ADDENDUM #05

Project Name: Central County Fire & Rescue – HQ, Training, Maintenance

Project Number: 23121

Date: October 28, 2025

Project No: **2464**
 Sheet No: **C7.0**
 09/16/2025

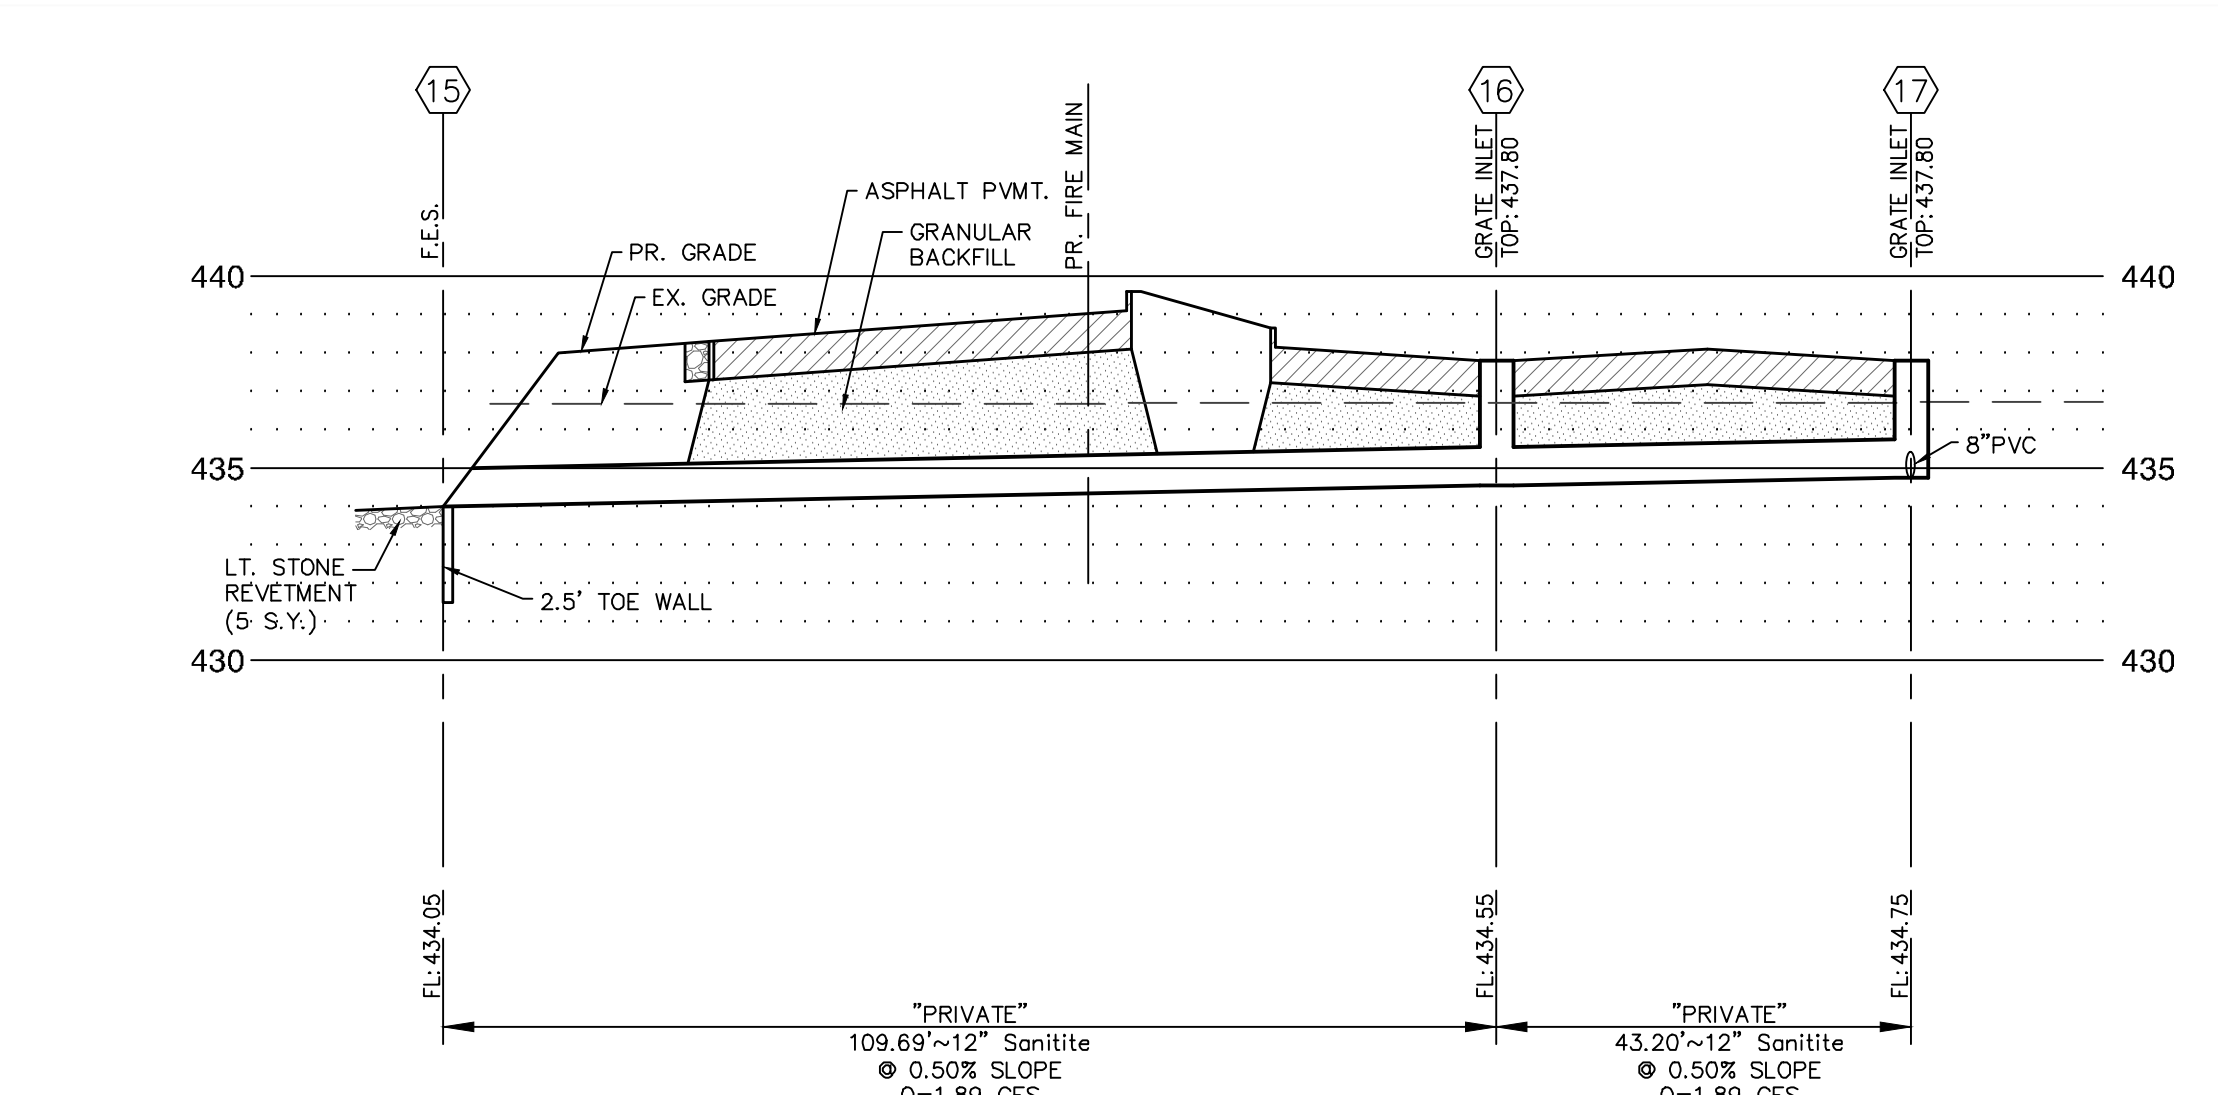
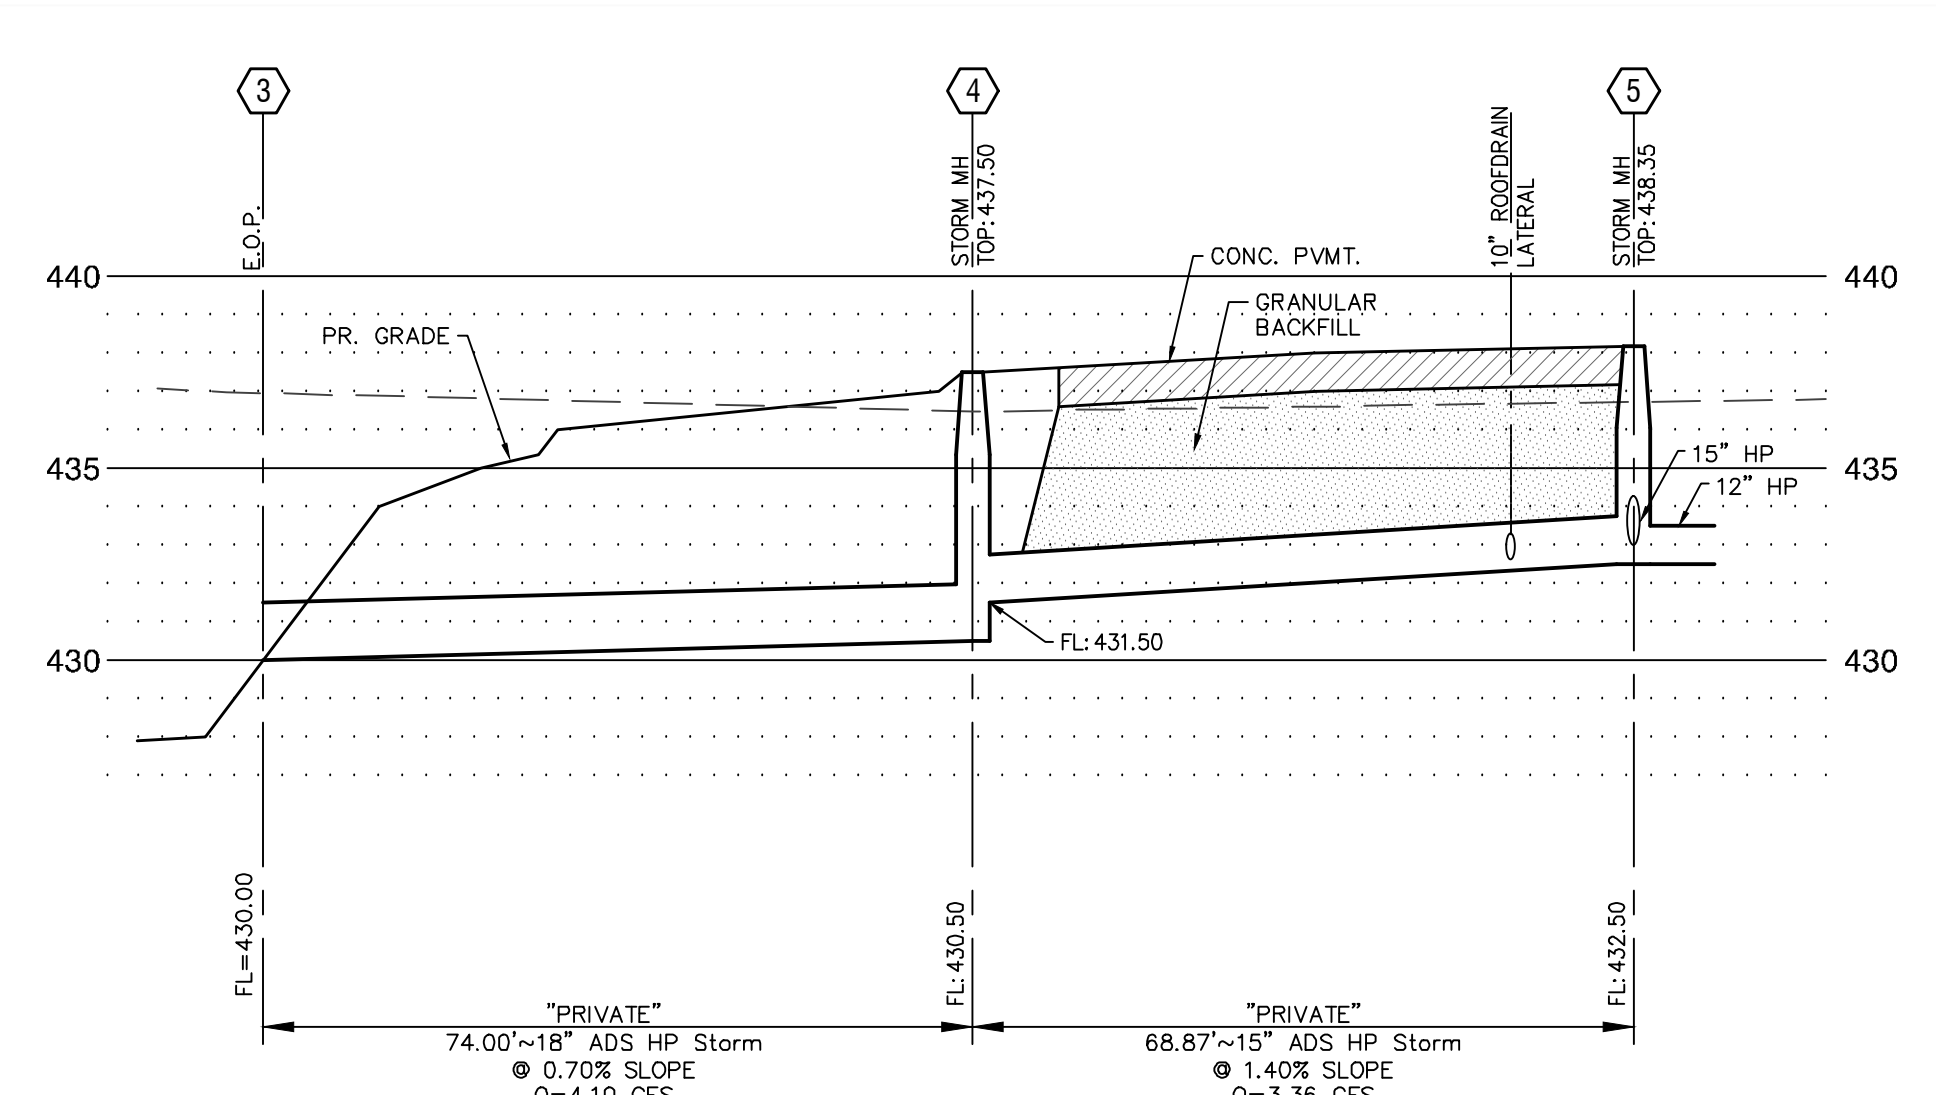
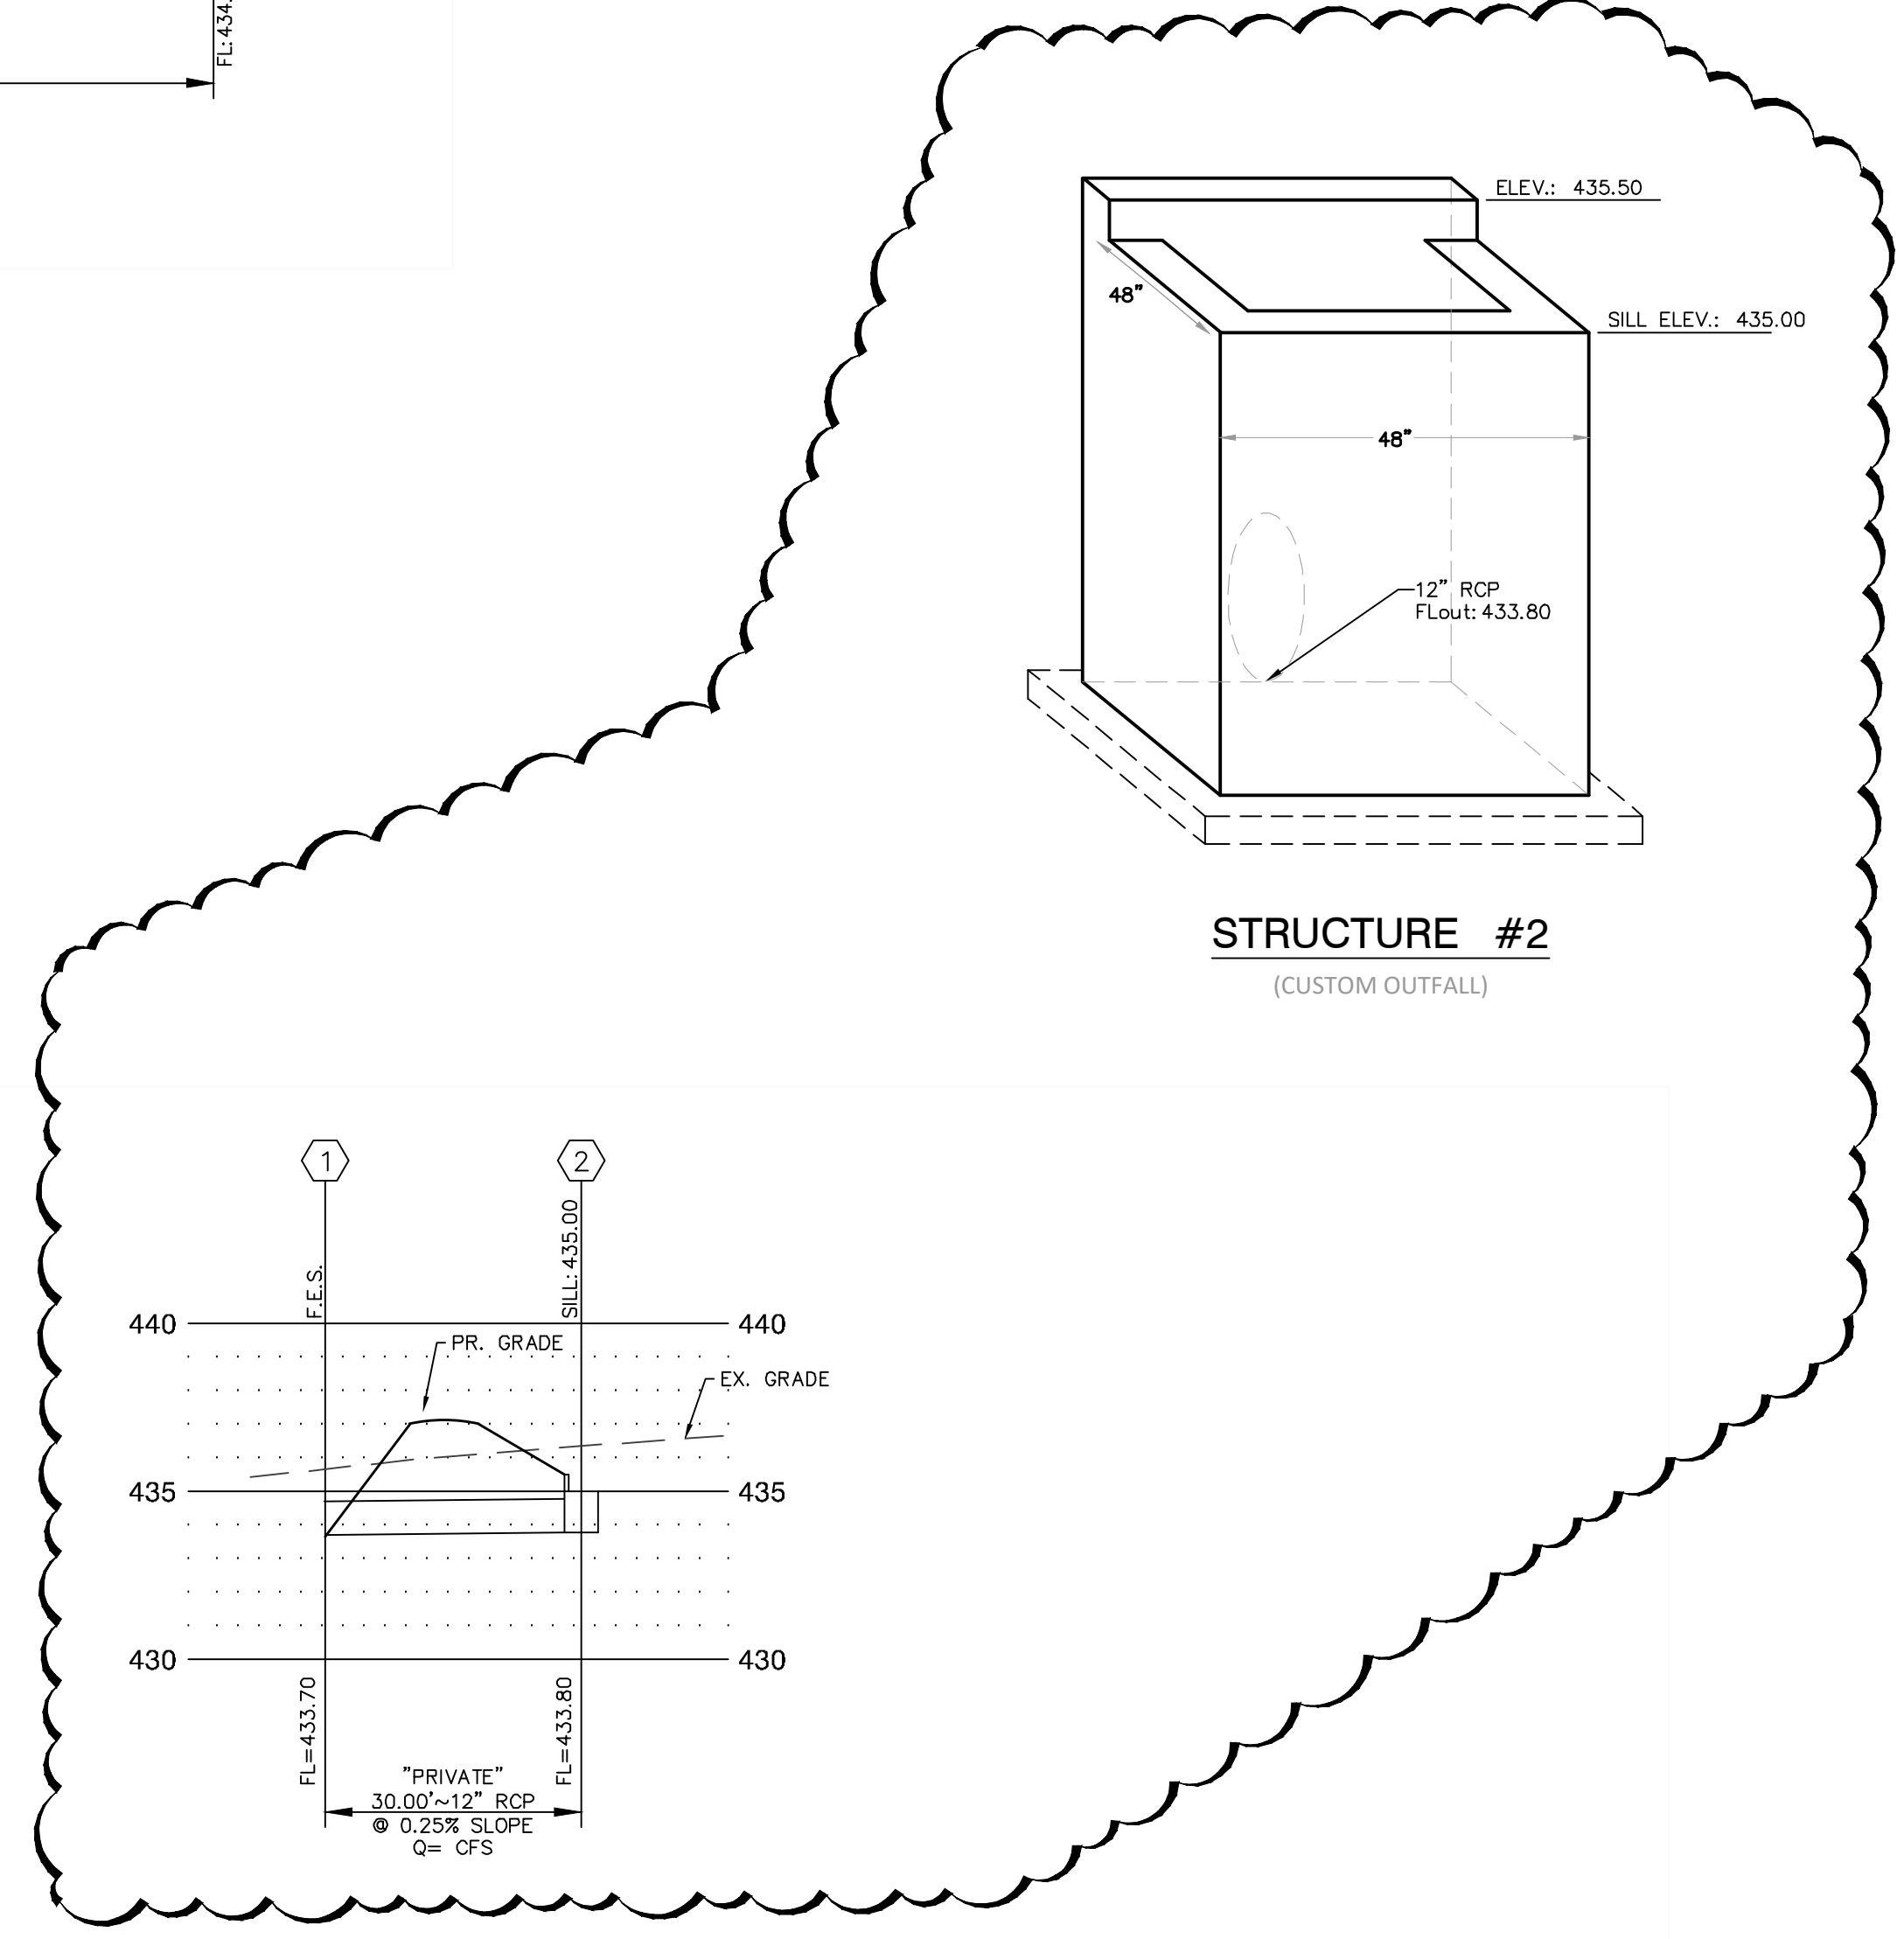
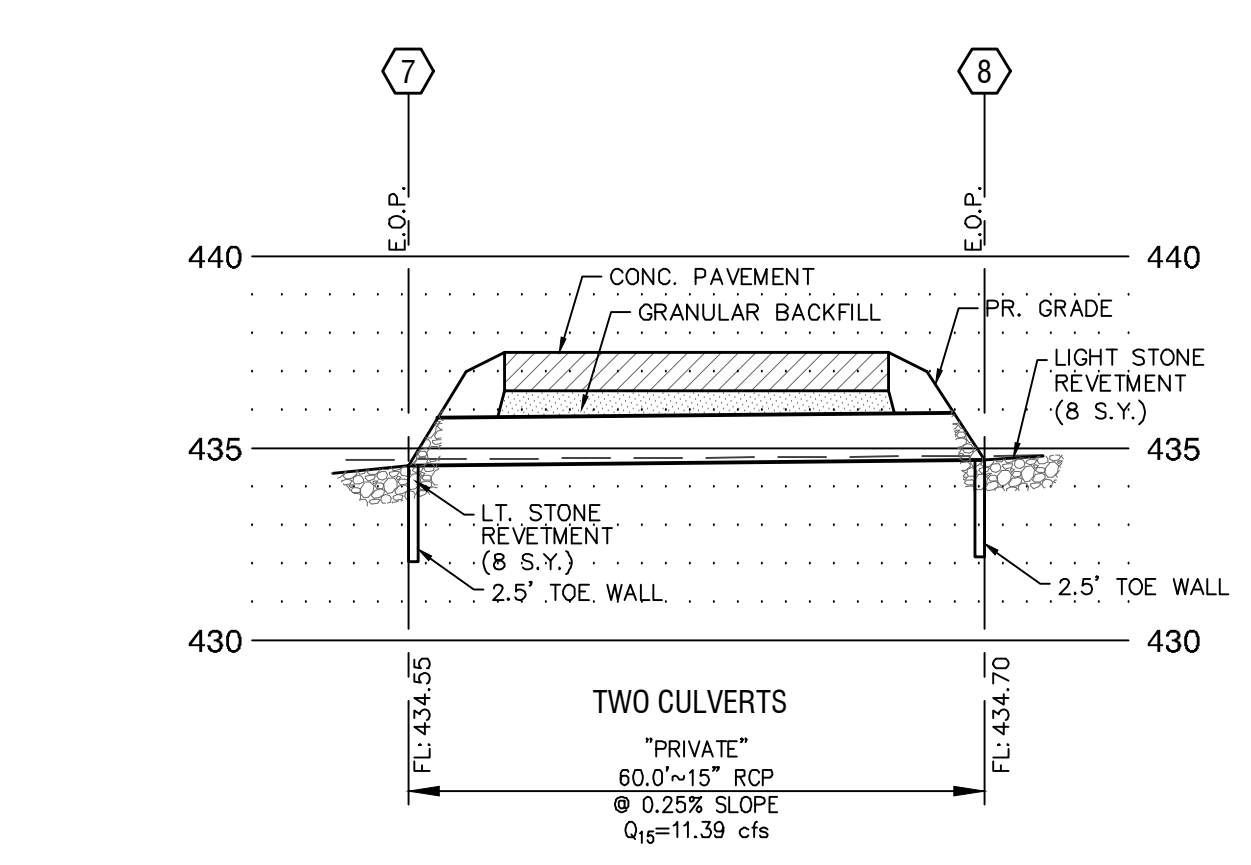
1. Sheet C5.0 – Site and Grading Plan
 - a. **Added Force Main to the drawing**
 - b. **Reference attached Revised Sheet.**
2. Sheet C6.0 – Site Geometry and Utility Plan
 - a. **Moved 6" water line to the Northwest of the Maintenance Building**
 - b. **Reference attached Revised Sheet.**
3. Sheet C7.0 – Sewer Profiles
 - a. **Added sewer Structure and profile to drawing**
 - b. **Reference attached Revised Sheet.**
